# Access Compliance Report

## Public Rights-of-Way

### (Curb Ramps)

Intersection ID: 12779	Main Street: E_TRADE_ST	Cross Street: S_DAVIDSON_ST	Location: W
ADA ID: 77A850DB9D6F	Ramp Type: Perp	Initial Pass/Fail: Fail	Overall Compliance: No
Codes/Mitigation Info/Possible Solution		Field Measurements/Component Compliance

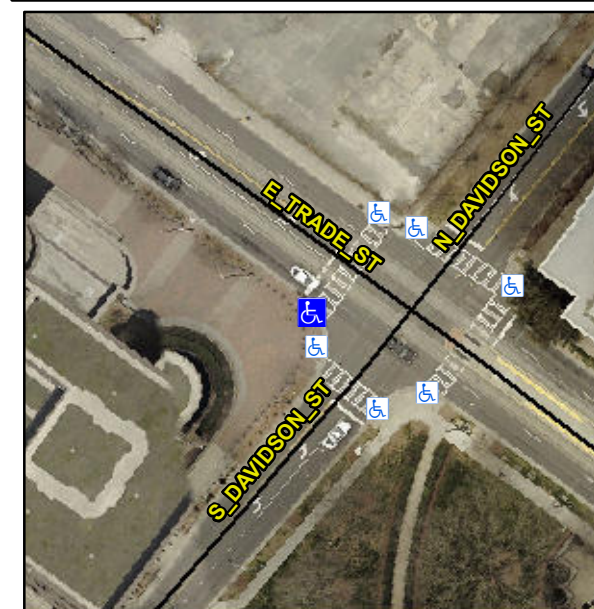
**Not Found, R304.2.2, R304.5.3**

Compliance	Description	Data	Compliance	Description	Data
N/A	Ramp Length (in)	72.0	No	Ramp Slope (%)	11.2
Yes	Ramp Width (in)	60.0	No	Ramp XSlope (%)	2.6
N/A	Flare Type LT	N/A	N/A	Flare Type RT	N/A
N/A	Flare Slope LT (%)	N/A	N/A	Flare Slope RT (%)	N/A
N/A	Flare Traversable LT?	N/A	N/A	Flare Traversable RT?	N/A
N/A	Landing Length (in)	N/A	N/A	DWS Provided?	N/A
N/A	Landing Width (in)	N/A	N/A	DWS Contrast?	N/A
N/A	Landing Slope (%)	N/A	N/A	DWS Length (in)	N/A
N/A	Landing X Slope (%)	N/A	N/A	DWS Full Width?	N/A
N/A	Landing Curb? (Y/N)	N/A	N/A	DWS Offset (in)	N/A
N/A	Shared Landing?	N/A			
N/A	Gutter Ponding?	N/A	N/A	Gutter Slope (%)	N/A
N/A	Gutter Lip Ht (in)	N/A	N/A	Gutter X Slope (%)	N/A
N/A	Painted X Walk1?	Yes	N/A	Painted X Walk2?	N/A
	X Walk 1 Direction	To NE		X Walk 2 Direction	N/A
N/A	X Walk 1 Width (in)	110.0	N/A	X Walk 2 Width (in)	N/A
	X Walk 1 Slope (%)	5.2		X Walk 2 Slope (%)	N/A
	X Walk 1 X Slope (%)	0.9		X Walk 2 X Slope (%)	N/A

**Remove & Replace Entire Ramp.**
